Access Compliance Report Public Rights-of-Way (Curb Ramps)

Intersection ID: 26032Main Street: CABOT_CRCross Street: CARMEL_COMMONS_BVLocation:SWADA ID: E49F6B481B90Ramp Type: PerpDiagInitial Pass/Fail: FailOverall Compliance: NoSeverity Score:22.5

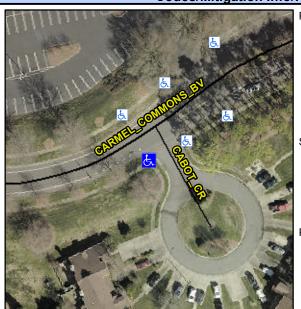
PROW/ADA:
R304.5.1, R304.2.2, R304.5.3

Field Measurements/Component Compliance					
Compliance Description		Data	Compliance Description		Data
N/A	Ramp Length (in)	71.0	No	Ramp Slope (%)	10.3
No	Ramp Width (in)	43.0	No	Ramp XSlope (%)	4.2
N/A	Flare Type LT	N/A	N/A	Flare Type RT	N/A
N/A	Flare Slope LT (%)	N/A	N/A	Flare Slope RT (%)	N/A
N/A	Flare Traversable LT?	N/A	N/A	Flare Traversable RT?	N/A
N/A	Landing Length (in)	N/A	N/A	DWS Provided?	N/A
N/A	Landing Width (in)	N/A	N/A	DWS Contrast?	N/A
N/A	Landing Slope (%)	N/A	N/A	DWS Length (in)	N/A
N/A	Landing X Slope (%)	N/A	N/A	DWS Full Width?	N/A
N/A	Landing Curb? (Y/N)	N/A	N/A	DWS Offset (in)	N/A
N/A	Shared Landing?	N/A			
N/A	Gutter Ponding?	N/A	N/A	Gutter Slope (%)	N/A
N/A	Gutter Lip Ht (in)	N/A	N/A	Gutter X Slope (%)	N/A
N/A	Painted X Walk1?	No	N/A	Painted X Walk2?	No
	X Walk 1 Direction	То Е		X Walk 2 Direction	To N
N/A	X Walk 1 Width (in)	N/A	N/A	X Walk 2 Width (in)	N/A
	X Walk 1 Slope (%)	2.4		X Walk 2 Slope (%)	0.5

X Walk 1 X Slope (%)	0.4		X Walk 2 X Slope (%)	1.5
N/A	Ramp inside XWalk1?	N/A	N/A	Ramp inside XWalk2?	N/A
	Road Slope (%)	0.9	N/A	Clear Space?	N/A
	Road X Slope (%)	2.3	N/A	Clear Space to XWalk (in)	N/A
N/A	Any Obstructions?	N/A	N/A	Storm Grate/Utility Hazard?	N/A
	Obstruction Type			Storm Grate/Utility Type	
		N/A			N/A
			Yes	Surface Condition? (G/P)	Good
Land Control	31.77	,	-

CABOT CR StopSign CARMEL COMMONS BV None Possible Solutions:

Remove & Replace Curb Ramp With
Two New Directional Ramps or
Equivalent.
